## Product Change Notification / NTDO-29TVUD658

CCB 4623 Final Notice: Qualification of STA as an additional assembly site for LAN9220, LAN9221, LAN9500 and USB2524 SMSC device families available in 56L VQFN (8x8x0.9mm) package

**CCB 4623**  
**Pre and Post Change Summary**  
**PCN #NTDO-29TVUD658**

# Lead frame Comparison

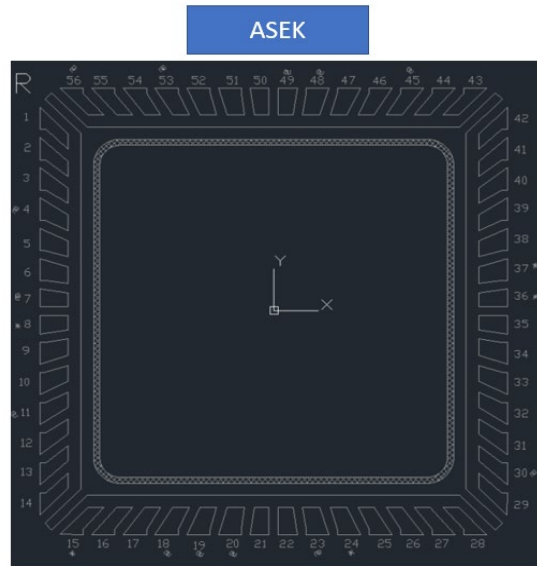
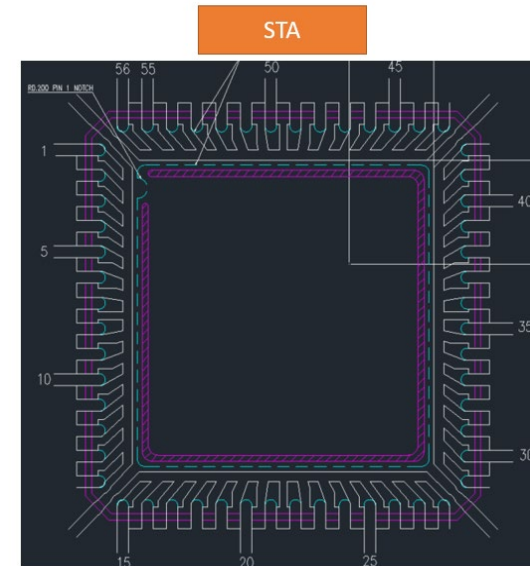
Pre Change		Post Change		
<b>Assembly Site</b>	ASE Inc. (ASE)		ASE Inc. (ASE)		STATS Chippac Ltd. (STA)
<b>Wire material</b>	PdCu	Au	PdCu	Au	CuPdAu

<b>Die attach material</b>	EN-4900F	EN-4900F	8290
<b>Molding compound material</b>	G631B	G631B	G700E
<b>Lead frame material</b>	C194	C194	C194
<b>Lead frame paddle size</b>	240X240 mils	240X240 mils	236X236 mils
	See attached pre and post change comparison		
<b>DAP Surface Prep</b>	Double Ring	Double Ring	Ring Plating
